City of Mississauga Department Comments

Date Finalized: 2023-10-25	File(s): A403.23
To: Committee of Adjustment	Ward: 11
From: Committee of Adjustment Coordinator	Meeting date:2023-11-02 1:00:00 PM

The applicant requests the Committee to approve a minor variance to allow the construction of a below grade entrance proposing an interior side yard setback of 0.05m (approx. 0.16ft) whereas By-law 0225-2007, as amended, requires a minimum interior side yard setback of 1.20m (approx. 3.94ft) in this instance.

Property Address: 6845 Golden Hills Way

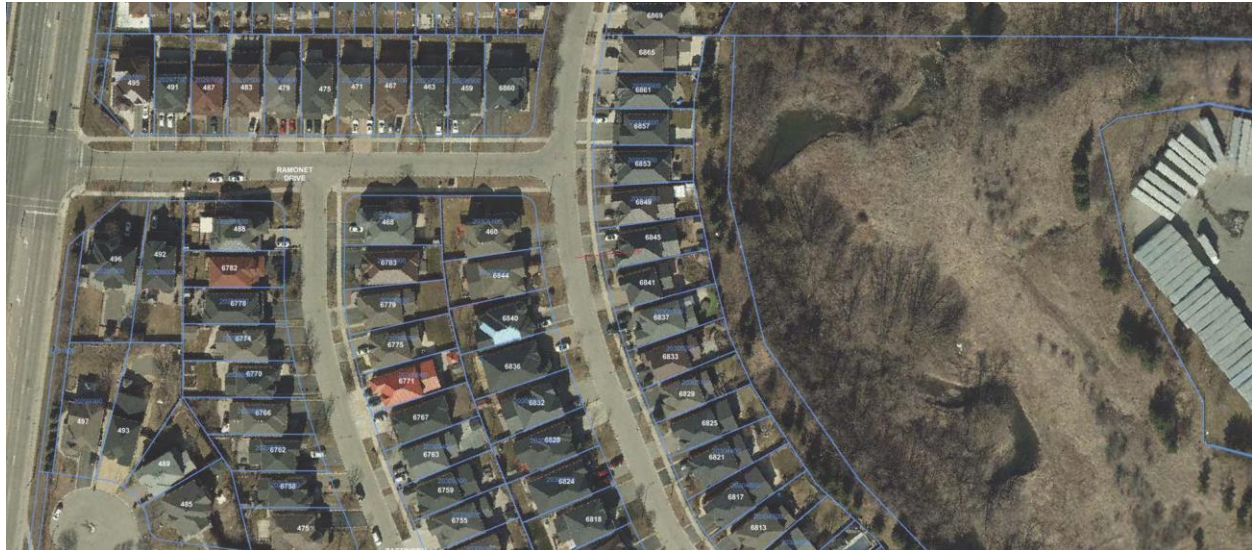
The applicant proposes a 0.05m (0.16ft) interior side yard setback where a minimum 1.20m (3.94ft) is required. The general intent of interior side yard setback requirements is to ensure that an adequate buffer exists between the massing of primary structures on adjoining properties, that access to the rear yard ultimately remains unencumbered, and that appropriate drainage patterns

can be maintained. Transportation and Works staff have raised concerns that the proposal for a basement entrance in the side yard will prevent the ability to provide the space required to accommodate a required drainage swale and therefore redirect the surface drainage onto the neighbouring lot.

Enclosed for Committee's reference are photos which depict the area where the below grade entrance is being proposed. We note that the Grading Plan approved for this property for Lot #8 Plan 43M-1479 (Grading Plan C-38628 by Urban Ecosystems Ltd) depicts a rear to front drainage pattern meaning drainage from the rear yard was designed to be directed to the front via side yard swale. A reduction in side yard setback to 0.05M (approx. 0.16 ft.) whereas 1.20M is required, does not allow for a functional drainage swale between the properties. Typically, if this variance was approved it would result in some drainage from this property being directed onto the adjacent property, however in this particular instance the abutting neighbour has also constructed a below grade entrance approximately in the same area which further impleads the approved drainage pattern for this property.

In view of the above, we have concerns with the request and do not support the significant reduction in side yard setback to 0.05M (approx. 0.16ft). Our suggestion would be that the applicant redesign the proposal to reflect a side entrance where the door opens internally and this would eliminate the requirement for the below grade entrance in the side yard and the potential drainage issue.

Staff recommend that the application be deferred in order to allow the applicant to redesign or relocate the proposed entrance.
